ZENITH RADIO CORP.

MODEL 4G800
Chassis 4E41

Zenith 4G800 Chassis 4E41

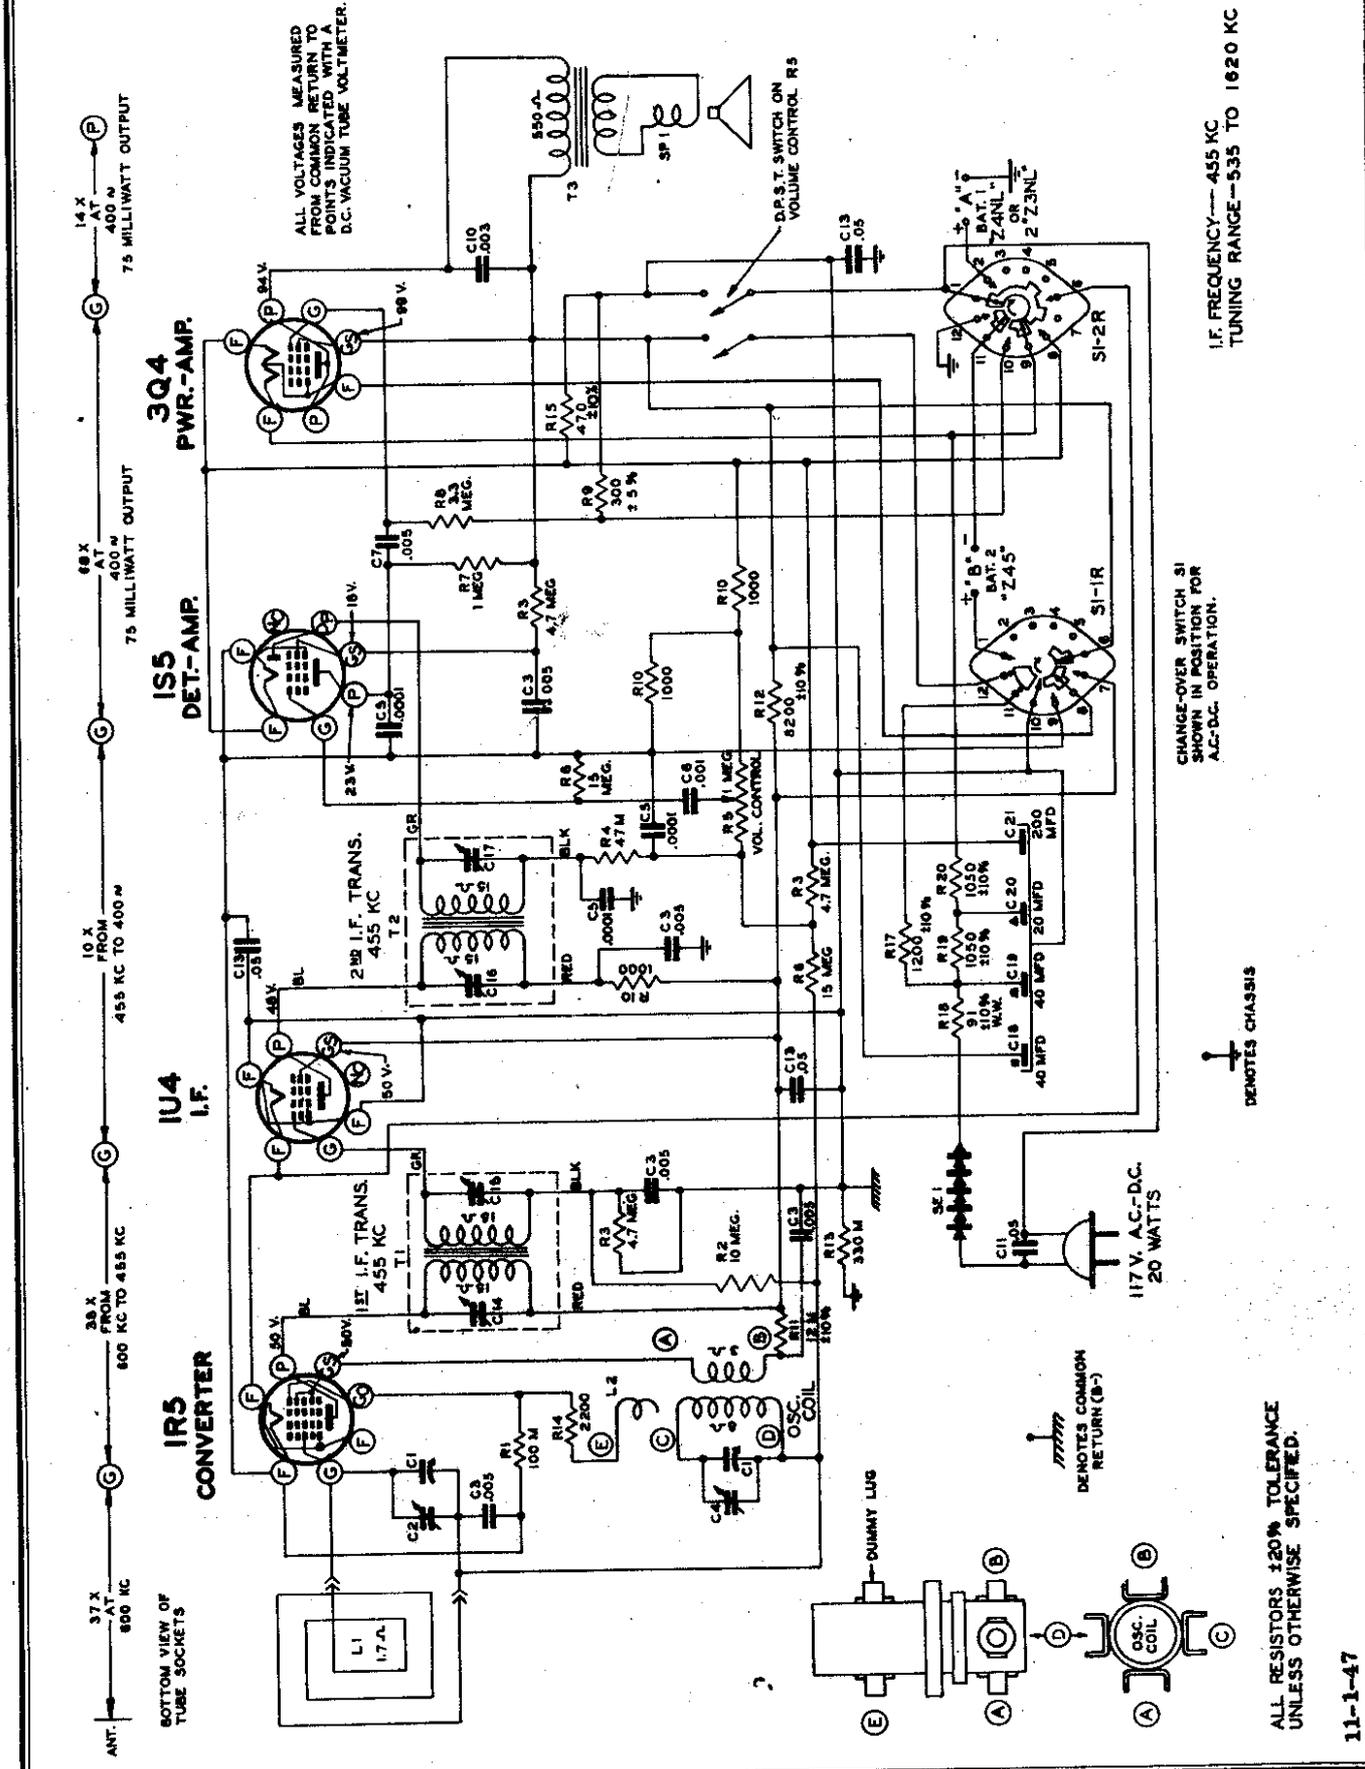
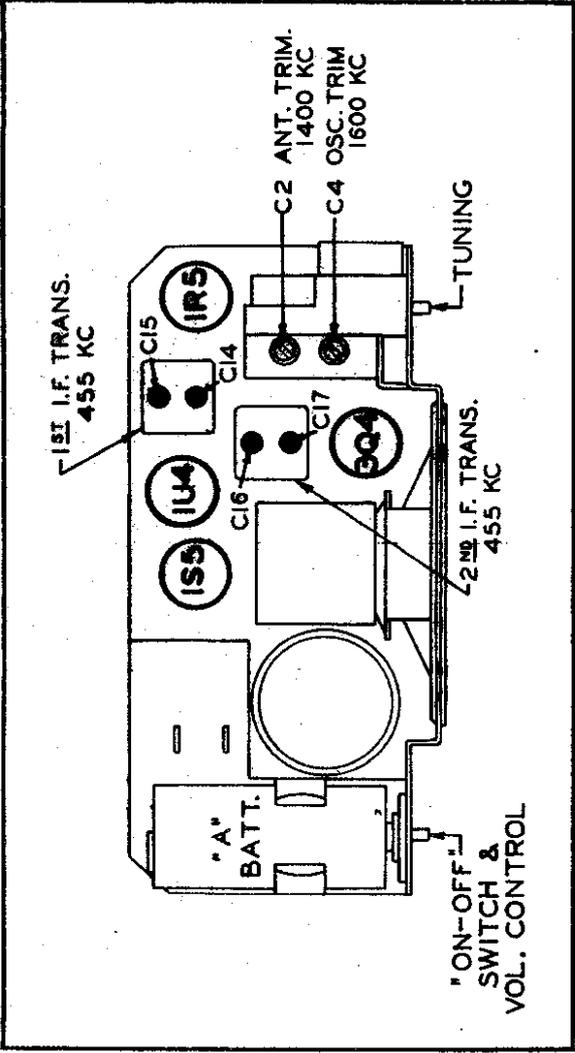
This model appears in *Volume XVII of Rider's Manuals, pages 17-1 and 17-2*. The On-Off switch #85-433 does not completely break contact on some receivers when the lid is closed, causing battery drain. To correct this condition, saw one plastic switch knob 46-736 into 1/16" lengths and place a length on the switch shaft, and then replace the knob. This will force the switch down far enough when the lid is closed to break contact and disconnect the batteries.

In some cases the calibration pointer touches the metal front of the cabinet, thus putting the gang at an a-c potential and causing a hum. To correct this condition place a fibre washer #93-323 between the pointer and the metal dial front. This fibre washer between the metal front panel and the dial pointer, completely prevents this "shorting" condition.

On later production runs the 3Q4 tube was replaced with a 3V4 tube. The circuit remains the same in this case. However, the wiring to the tube base has been altered. The 3Q4 is not interchangeable with the 3V4 because of socket connections.

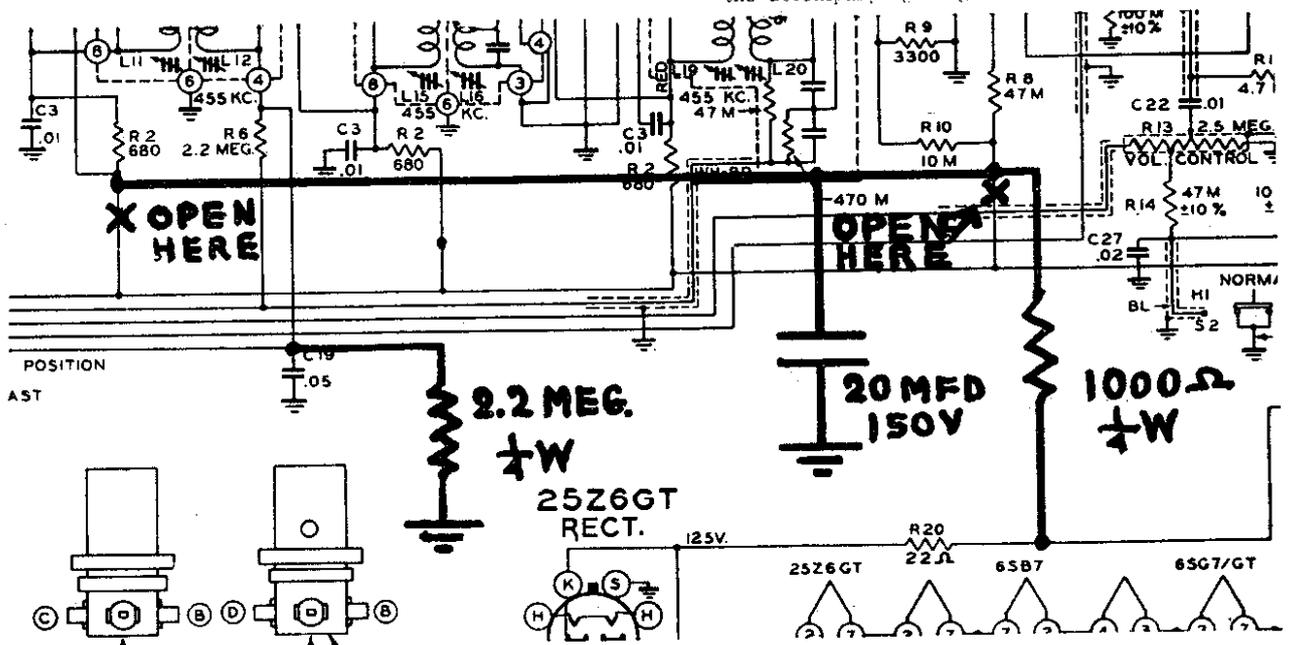
Enough extra lead length should be left when replacing the wavemagnet lead on the Zenith 4G800 so that a break does not occur at the point indicated.

In some cases when the front lid of the receiver is open, the receiver will cut in and out or sometimes be entirely dead. The wire from the wavemagnet to the front door hinge may break at the hinge connection. To correct this condition, remove the handle and resolder these leads, being quite certain that solder is not allowed to run back on the antenna lead and that enough extra antenna lead is allowed for flexing to prevent breakage when the door is open as illustrated in the accompanying diagram.
